Access Compliance Report Public Rights-of-Way (Curb Ramps)

Main Street: SKLAR_ST		Cross Street: AVENDALE_BLVD		Location:	SW
ADA ID: RPRK211102171554	Ramp Type: Type 4 - Parallel	Initial Pass/Fail: Fail	Overall Compliance: No	Severity Score:	15
Codes/Mitigation Info/Possible Solution			Field Measurements/Component Compliance

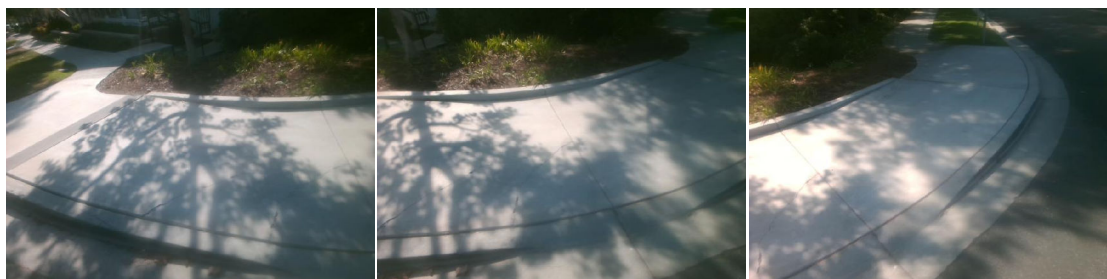
R304.3.2, STD 1115

Remove & Replace Curb Ramp With Two New Directional Ramps or Equivalent.
